Inspection Report for North Sturbridge Road Solar Facility

NPDES ID No.: MAR10031G

Inspection Date: 6/20/2022

**FIGURE 1:
SWPPP
INSPECTION
SKETCH
6/9/2022**

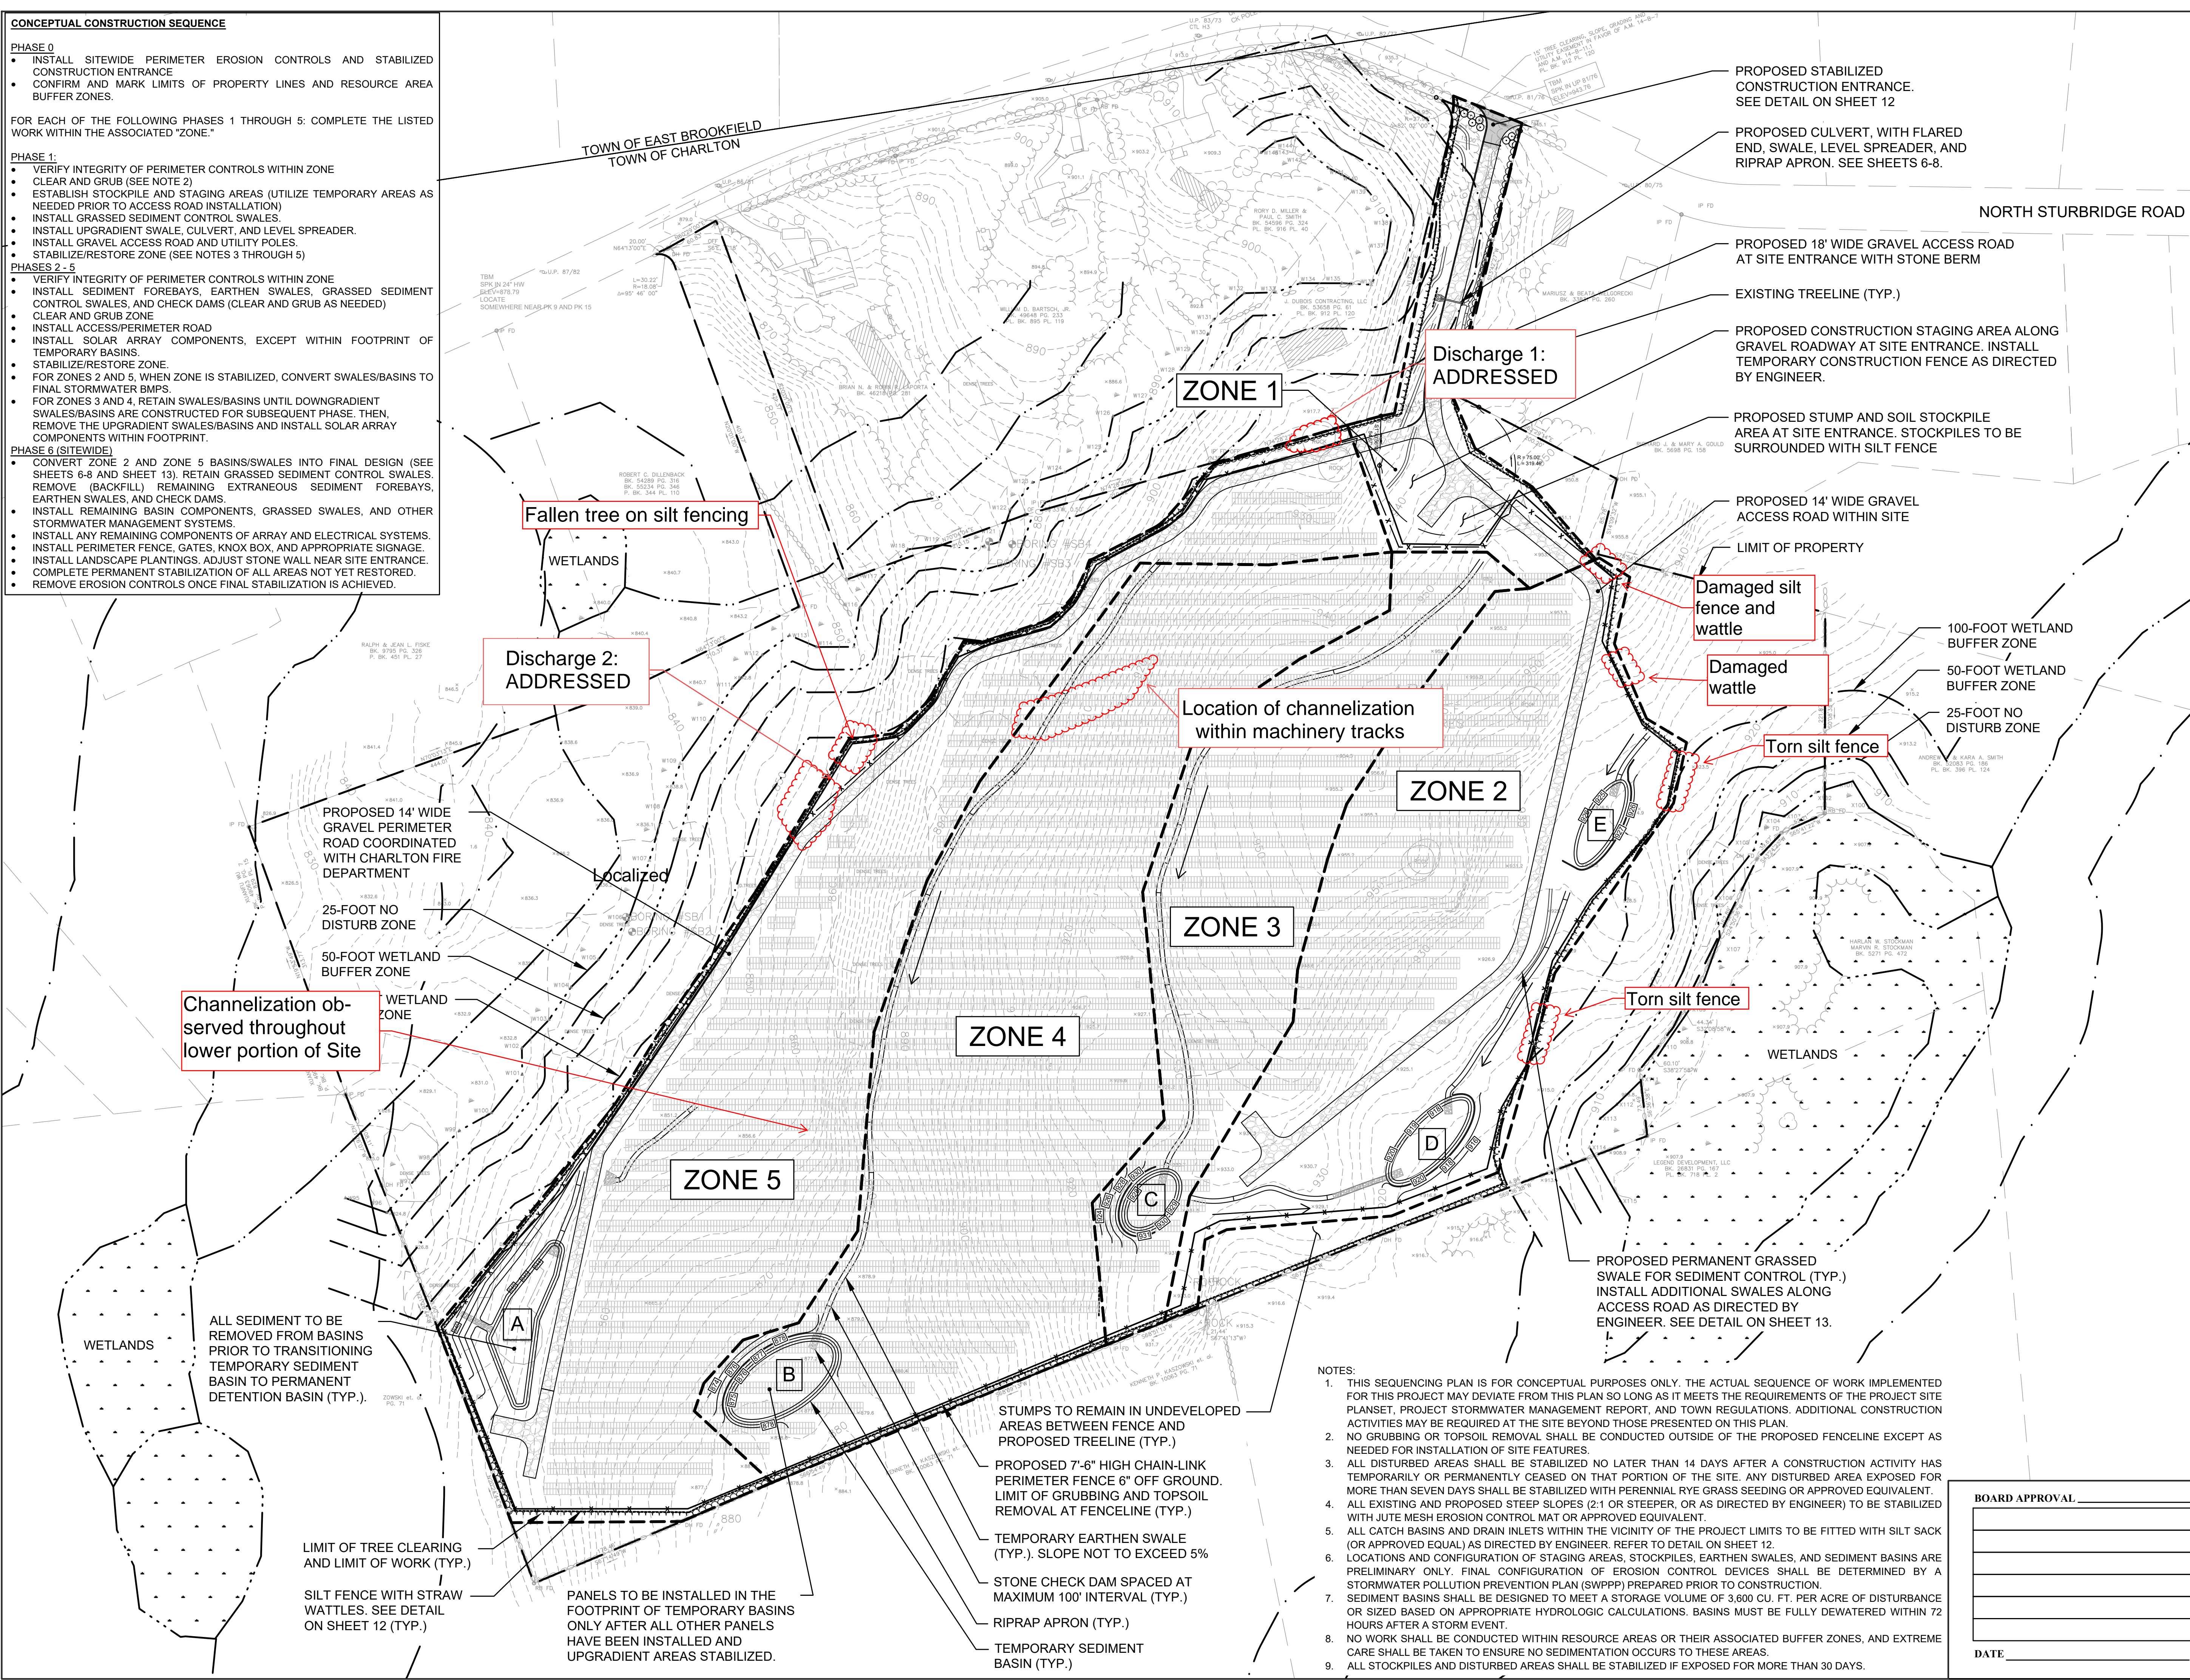
Damaged silt fence and wattle

Damaged wattle

Torn silt fence

Torn silt fence

Channelization observed throughout lower portion of Site

Fallen tree on silt fencing

Discharge 2: ADDRESSED
